VEHICLE SAFETY DEFECT SERVICE BULLETIN
NHTSA Recall Campaign #05V-556

Jayco, Inc. has found that there was an error on six –(6) serial number ranges on our header page for the instruction sheet. The models are 2004 MU, RZ, UA, UG, UM, and UU. Attached is the revised header page and instructions for your records.

Subject:	Hitch reinforcing plates missing from installation	
Units Affected:	2004 - 2005 Ambient, Escapade, Greyhawk & Granite Ridge Motorhomes	
	• 2004 Ambient › 46M10050 – 0097 › 46M20051 – 0057 › 46M30051 – 0059 › 46M40051 – 0058 › 46M50051 – 0071	• 2005 Ambient › 56M10051 – 0064 › 51M10065 – 0067 › 56M20051 – 0055 › 56M30051 – 0055 › 56M50051 – 0055 › 51M50056

Fig. 1

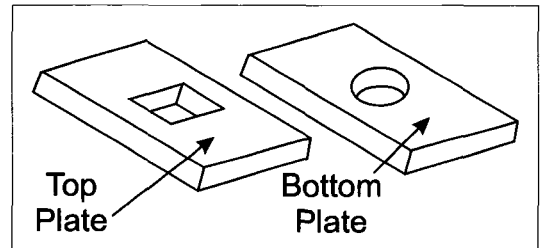
1. Inspect the mounting hardware that mounts the hitch to the frame rail. Each 1/2" carriage bolt needs to have a 3-1/4" x 1" x 1/4" top plate and a 2" x 1-3/16" x 5/32" bottom plate.
(Fig. 1)
2. If all eight (8) plates are not there, proceed to the following steps. If all the plates are there, complete the warranty claim for inspection time. (Fig. 2)
3. Inspect the top flange on the hitch. If there is any distortion around the hole or the top flange is bent, contact your Jayco customer service department for authorization and hitch replacement.
4. Remove each 1/2" carriage bolt one at a time and replace the hardware as shown.
5. Repeat for all three (3) bolts.
6. Torque all 1/2" carriage bolts to the specified range as listed on the installation instructions for the hitch attached.
